**Statement of Compliance
Access for People with a Disability**

**Proposed Mixed Use
Development**

154-158 Pacific Pde Dee Why

Report Type: Statement of Compliance - BCA Access Provisions
Development: 154-158 Pacific Pde Dee Why

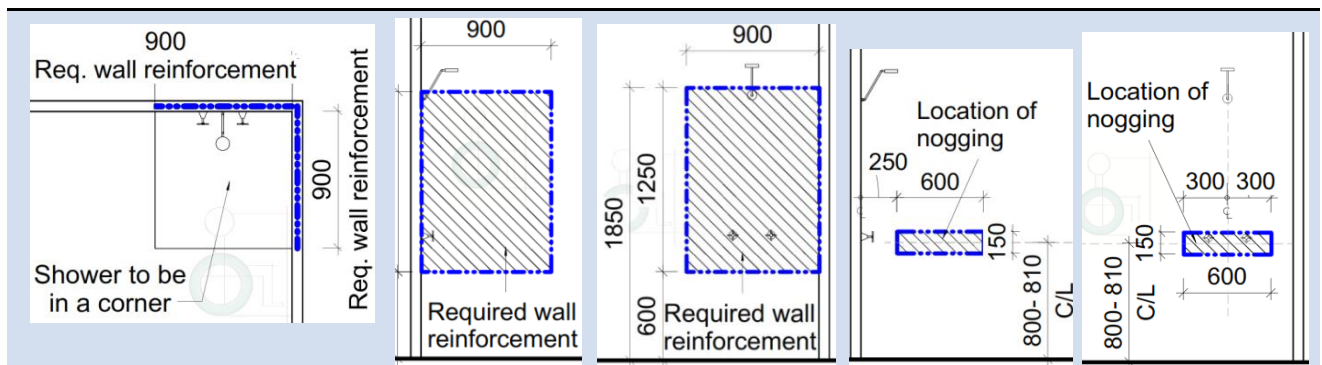
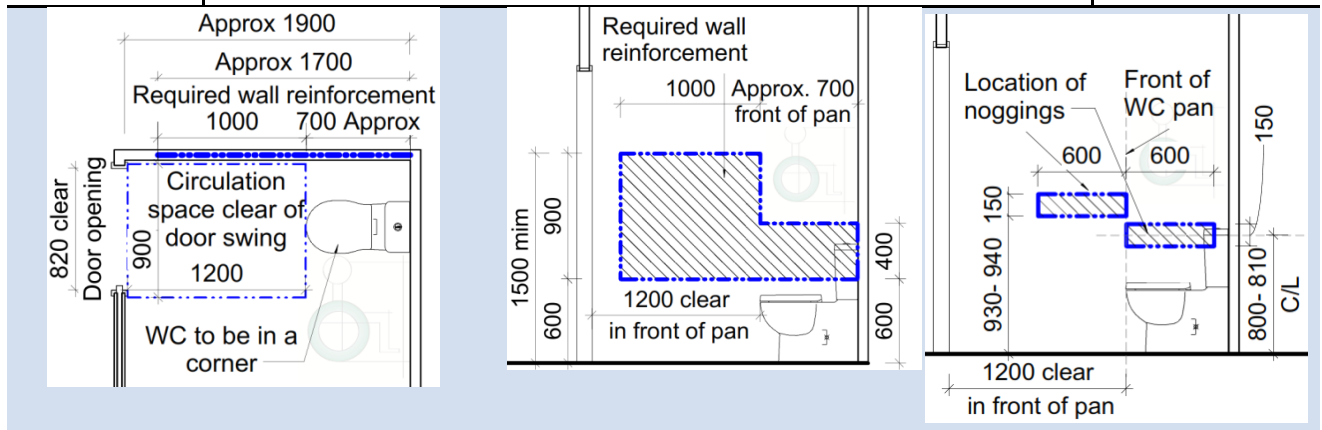
Since **1** of the units (**Unit 1**) already complies with the Adaptable unit requirements, these units are also capable of satisfying the intent of Silver level of Livable Housing Guidelines as noted in the table below.
